REPORT TO THE REGIONAL PLANNING COMMISSION

PROJECT NUMBER: PRJ2023-003106-(5)

PROJECT LOCATION: 1306 North Altadena Drive, Altadena
(Assessor's Parcel Number: 5751-005-020)

LA County Planning staff ("Staff") recommends that the Regional Planning Commission ("RPC") continue the public hearing to August 19, 2026 and direct the applicant to redesign Project Number PRJ2023-003106-(5), which includes CUP No. RPPL2023004561, MPD No. RPPL2023004570, and Variance No. RPPL2026001376, based on the Staff analysis and recommendations contained within this report.

COLORED
ELEVATIONS
Scale: 1/8" = 1'-0"
September 2, 2025

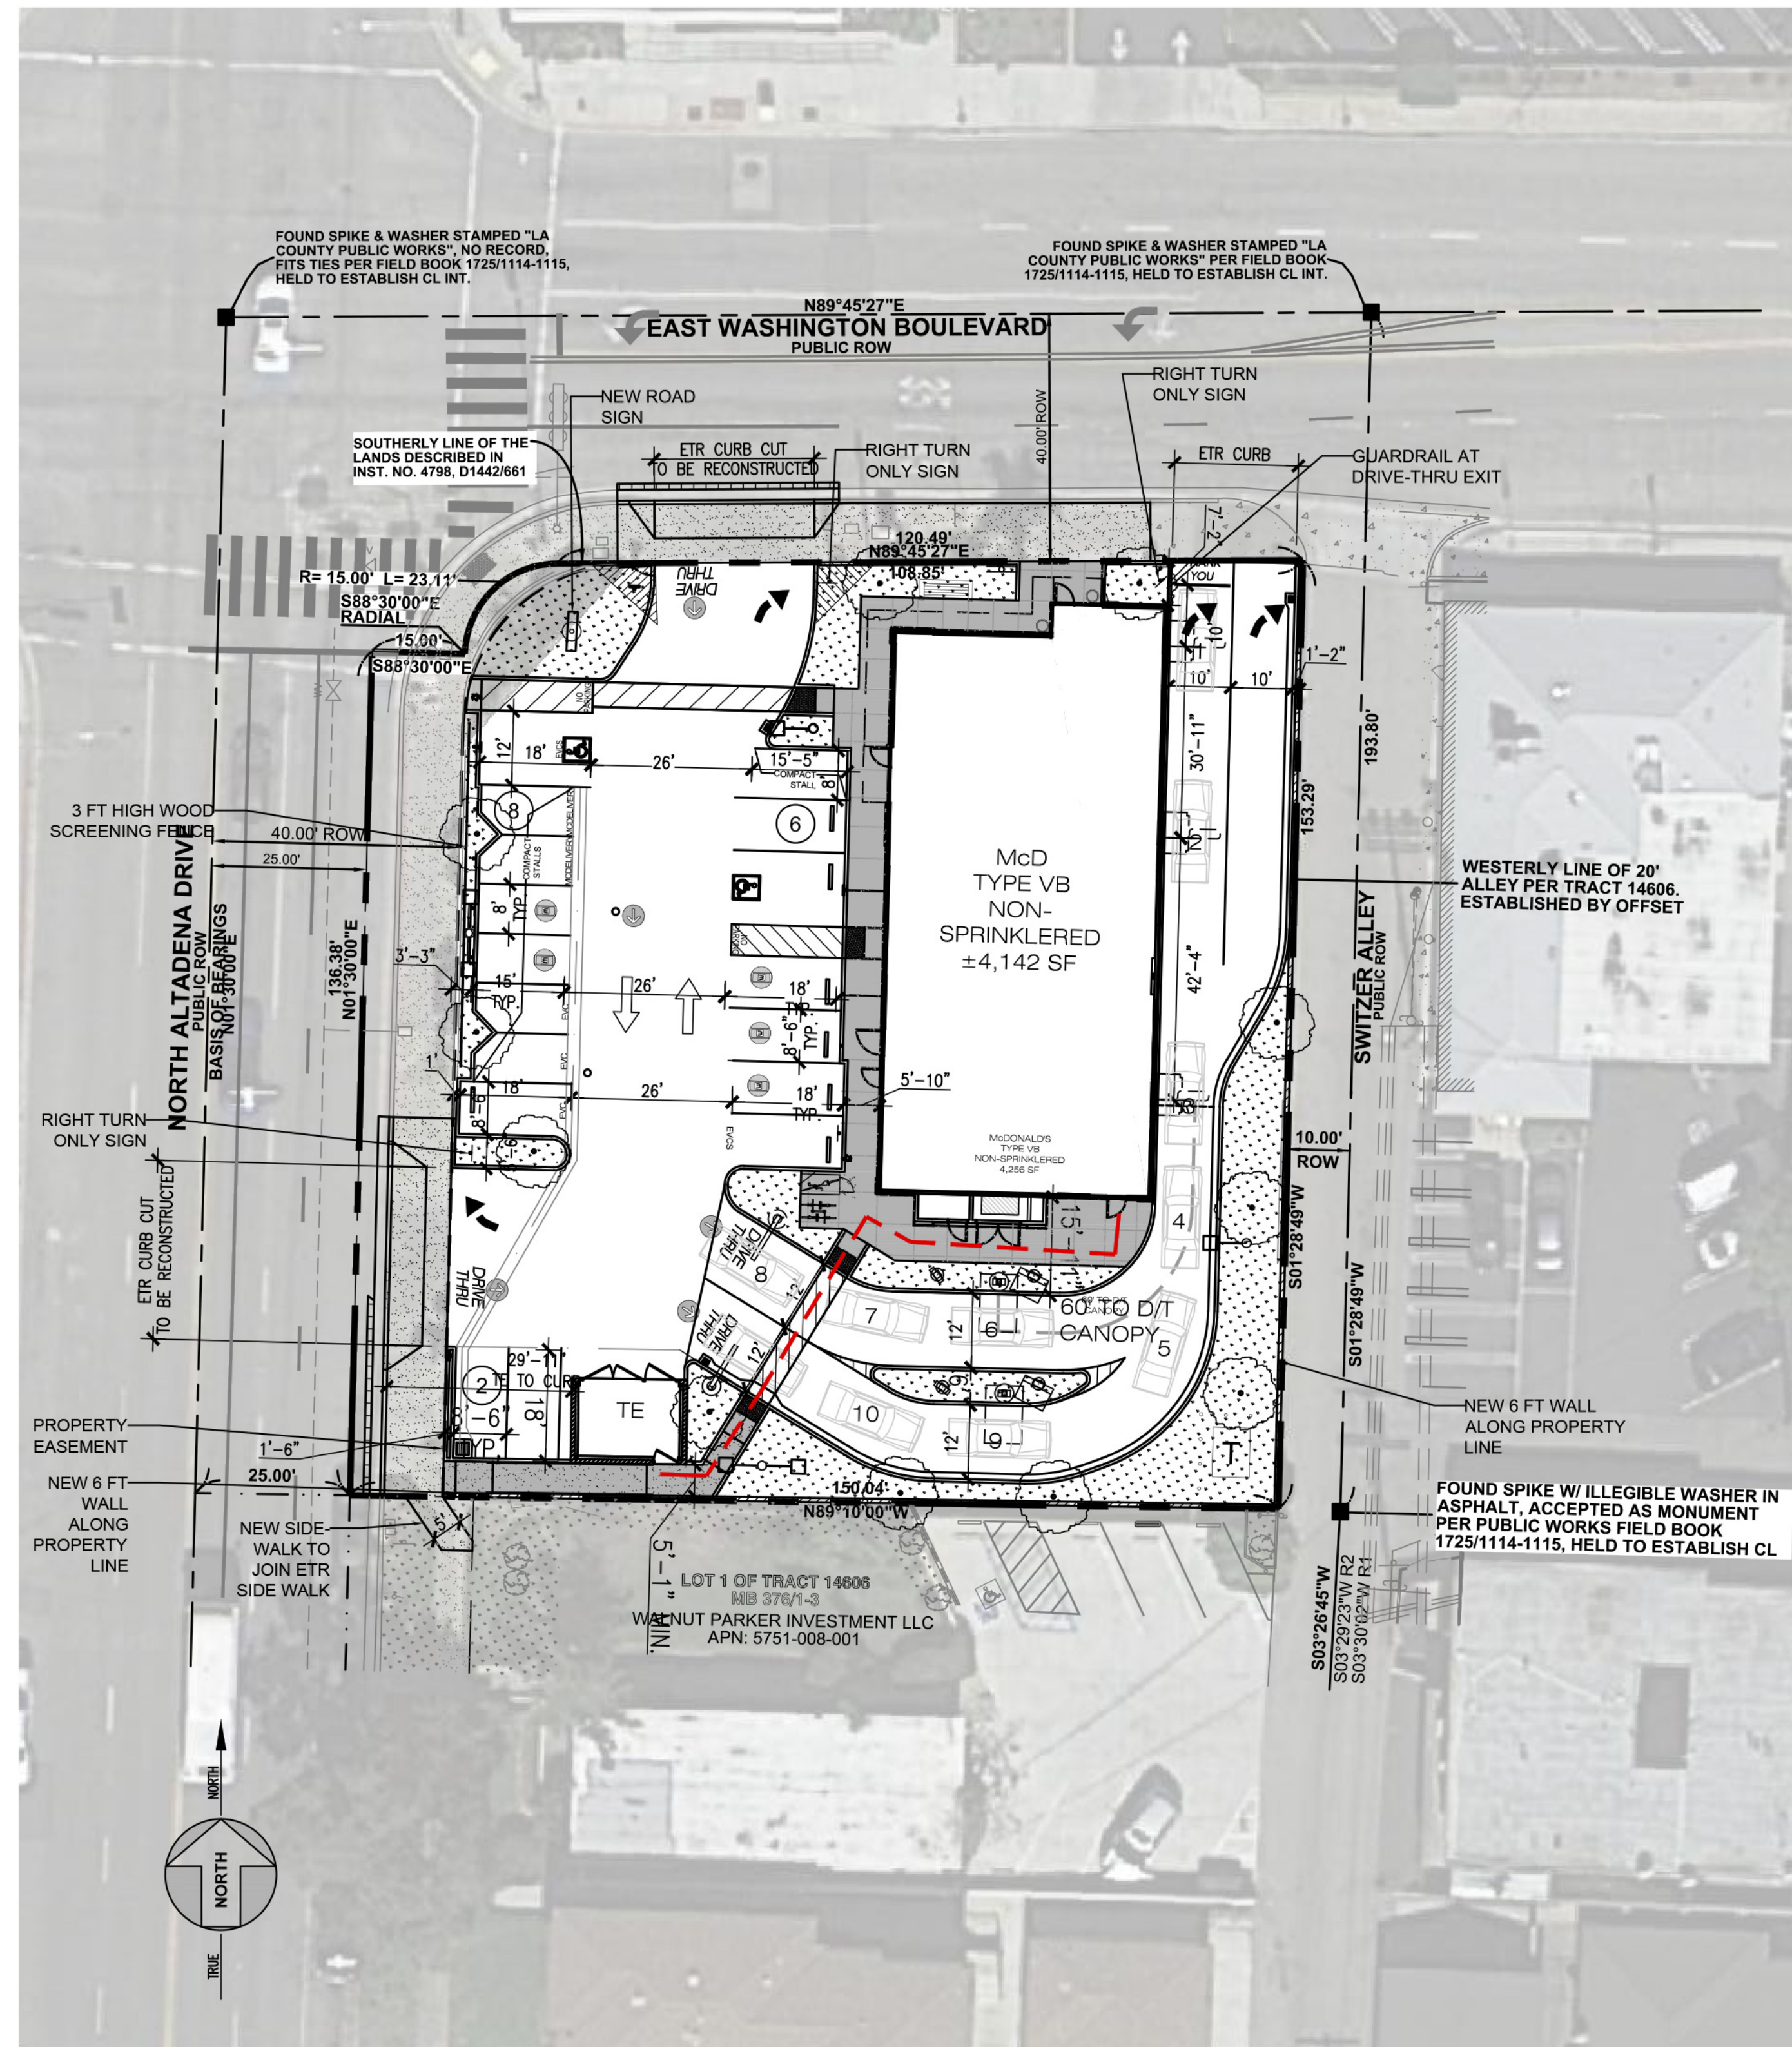
- **A mural in collaboration with a local artist** on the west building elevation facing Altadena Drive, potentially wrapping around to the north elevation to highlight the main pedestrian entrance. Staff recommended that the design of the mural could be coordinated with the design of the freestanding community identification sign to provide a cohesive and comprehensive design for the entire site. Staff also provided visual examples of existing murals in Altadena. The applicant declined to provide a mural on the building and instead suggested a mural on the proposed three-foot-tall wooden fence adjacent to Altadena Drive. Staff is of the opinion that a larger mural on the building would be more integrated into the overall project and

As outlined above, the design changes recommended by Staff would ensure that the Project is integrated into the built environment and reflective of Altadena's prevalent architectural styles. Given the eclectic nature of Altadena's built environment, Staff gave the applicant flexibility in terms of what architectural style to use. The applicant made a minimal effort to change the Project's massing, materials, color, detailing or ornament. The applicant stated that the use of "rectilinear forms, clean geometries, and flat roof lines" as well as "glass, wood siding, and brick veneer" contribute to the building's Mid-Century Modern aesthetic. However, the use of these elements in and of themselves do not constitute a Mid-Century Modern design. McDonald's standard modern corporate style utilizes rectilinear forms, clean geometries, flat roof lines, and glass. Likewise, wood siding and brick veneer are used in many different architectural vernaculars and are not inherently Mid-Century Modern. The building is lacking essential Mid-Century Modern characteristics, such as a low, horizontal profile, exaggerated sculptural elements, a dramatic roofline, or colorful design elements.

DOUBLE FACE ILLUMINATED FREESTANDING SIGN

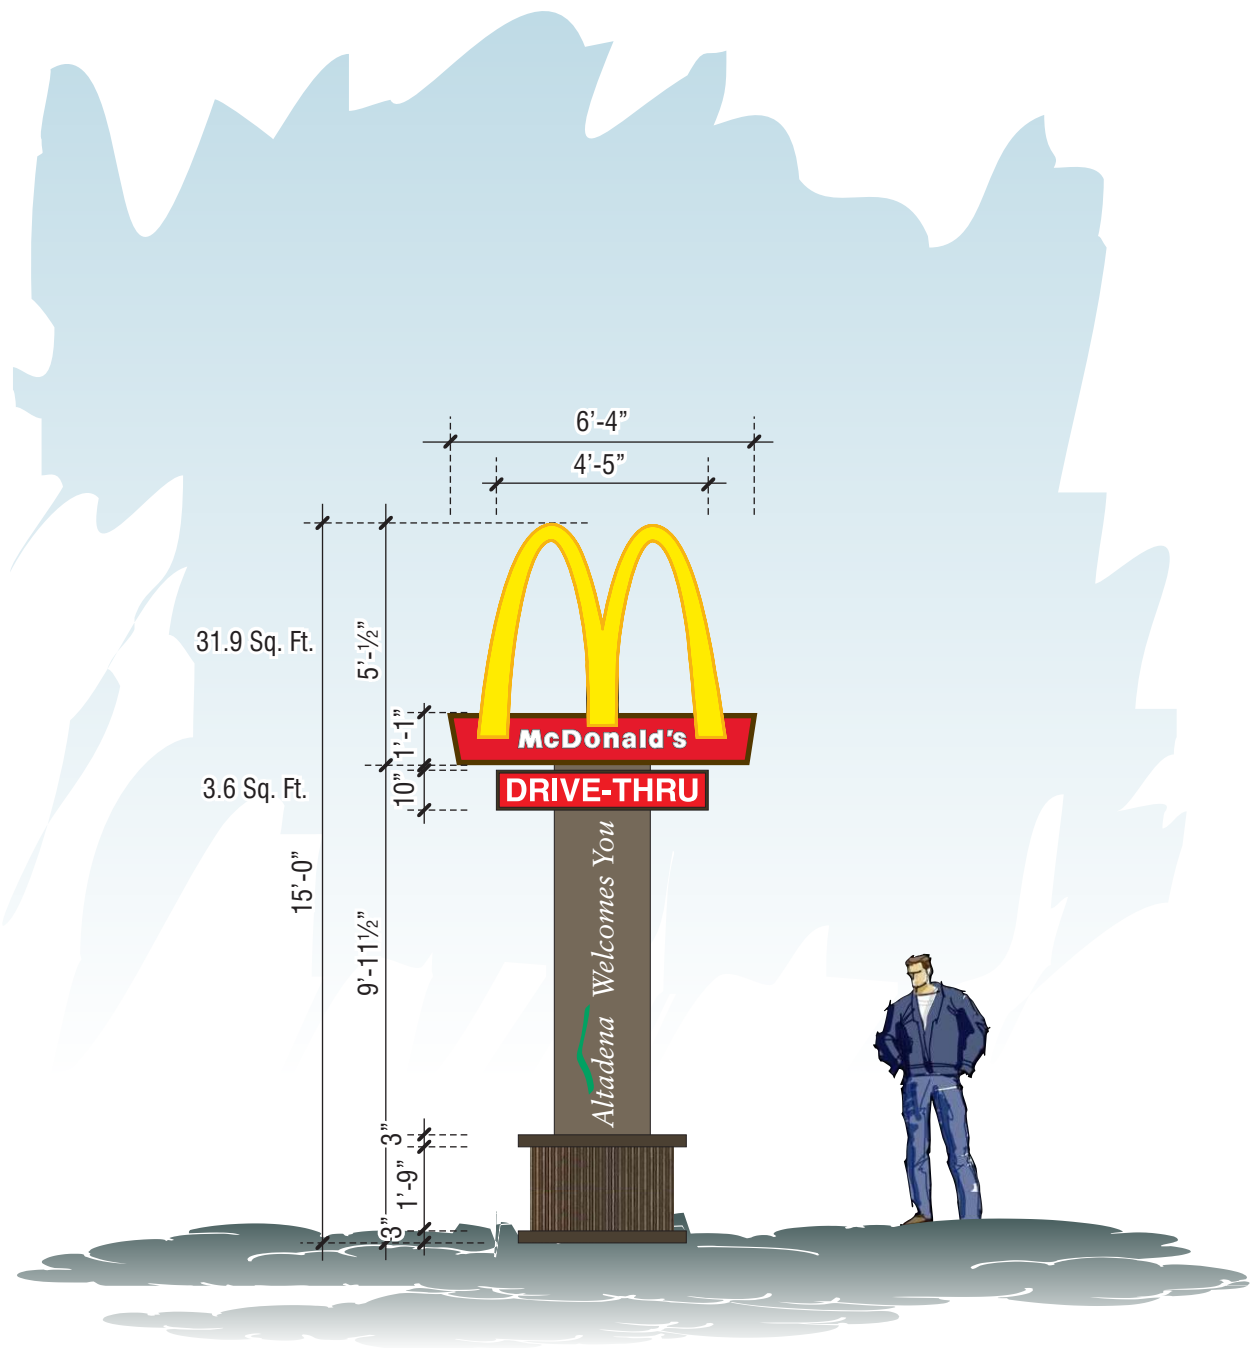
The Project also includes a Variance request for a 15-foot-tall pole-mounted freestanding sign at the intersection of Altadena Drive and Washington Boulevard that would replace the previous freestanding, monument-style sign. Pursuant to County Code Section 22.320.090.D.4 (Altadena CSD – All Commercial and Mixed Use Zones), freestanding signs may be permitted if they have a solid base that rests directly on the ground, do not exceed five feet in height, and do not exceed 40 square feet of sign area, or 40 square feet on each face if there are two or more faces. The proposed sign does not comply with the CSD. The CSD allows modifications related to the area

Staff does not recommend approval of the Variance because the proposed sign does not meet the Findings pursuant to County Code Section 22.194.050.B, as the modification would “constitute a grant of special privilege inconsistent with the limitations upon other properties in the vicinity and zone in which the property is situated.” The CSD signage regulations outlined above apply to all new signs on properties within Commercial and Mixed Use Zones, including the Project Site. In addition, there are no “special circumstances or exceptional characteristics applicable to the property” to justify the Variance. Requiring a monument-style sign in compliance with the CSD would not “result in practical difficulties or unnecessary hardships inconsistent with the general purpose of such regulations and standards.” Therefore, Staff recommends that the RPC direct the applicant to redesign the sign to comply with the CSD, eliminating the need for a Variance.
